**ALAMEDA COUNTY COMMUNITY DEVELOPMENT AGENCY  
PLANNING DEPARTMENT**

**SUPPLEMENT TO 2<sup>ND</sup> ADDENDUM TO PRIOR STAFF REPORTS**

**APPLICATION: CONDITIONAL USE PERMIT, PLN2014-00056**

**PROPOSAL:** To approve the Summit Wind Repower Project, to redevelop an existing wind farm through replacement of up to 569 older wind turbines with up to 31 new approximately 2.1 megawatt (MW) turbines, resulting in a maximum capacity of roughly 54 MW, and adding new technology and infrastructure.

FIGURE 16\* FOCUSED SHADOW FLICKER EFFECT MAP

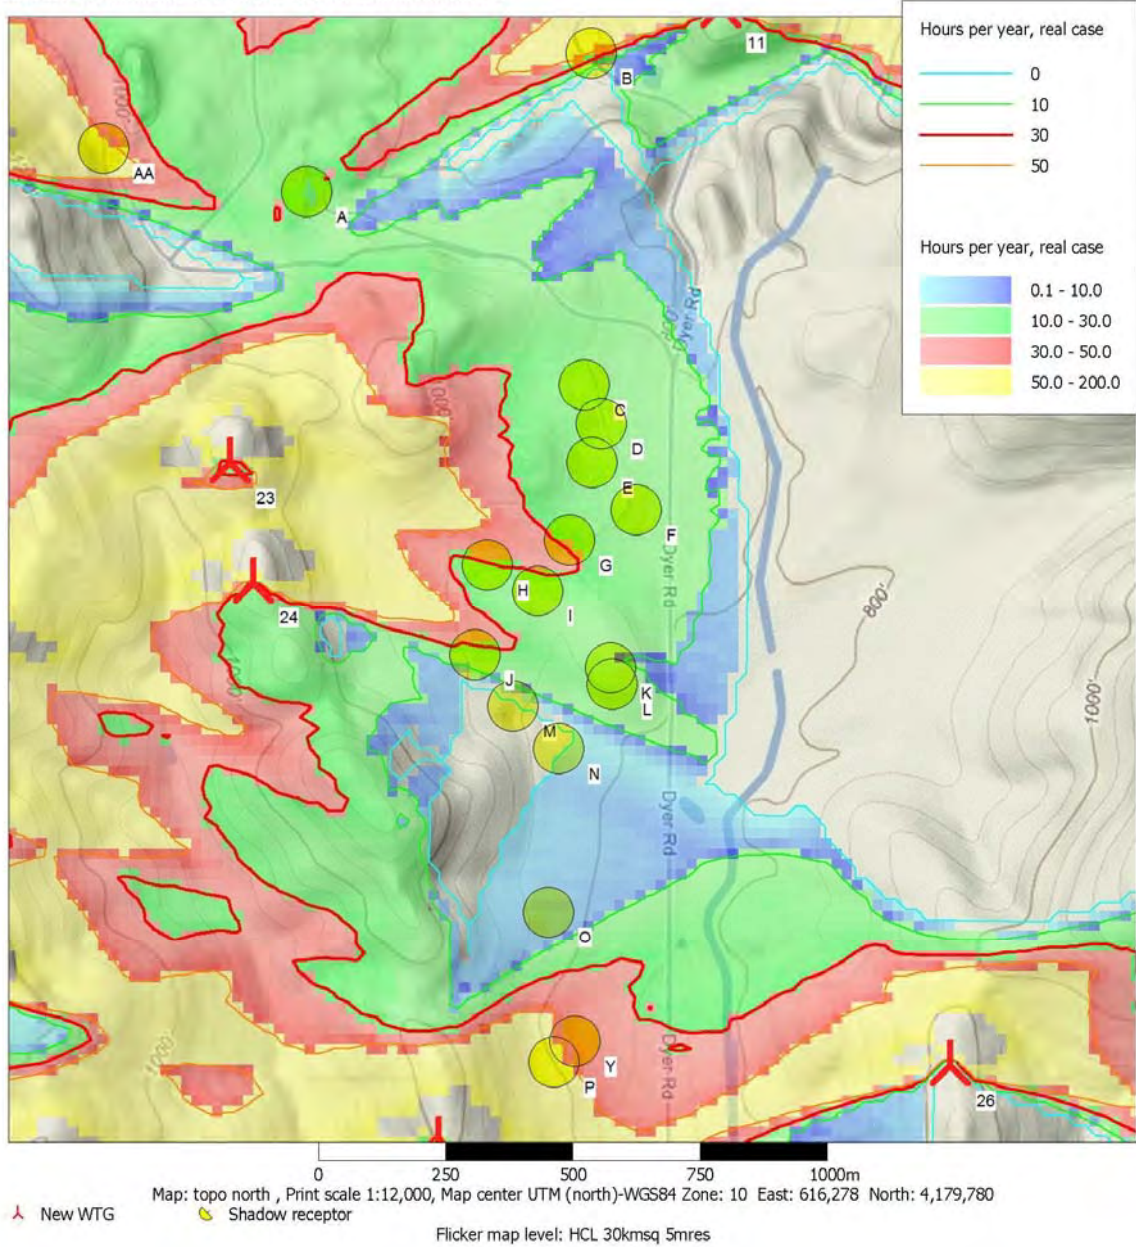
The replacement shadow flicker map and visual simulations of post-construction conditions without Turbines 29 and 30 are attached, which should replace Figures 13, 14B and 16 (pp. 21, 22 and 24) respectively in the Revised Supplemental Information report.

7. Rev. Supplemental Info, pg 24: Figure 16 (enlarged excerpt of shadow flicker map) is an enlargement of the Dyer Road area from an outdated (and no longer accurate) shadow flicker map. Please replace this map with the attached, updated map dated 12/05/15 (which is shown as Figure 14 in Power Engineers' Jan. 8 revised supplemental information memo).

\* REPLACES "ENLARGED EXCERPT OF SHADOW FLICKER MAP (FROM ATTACHMENT 11)"
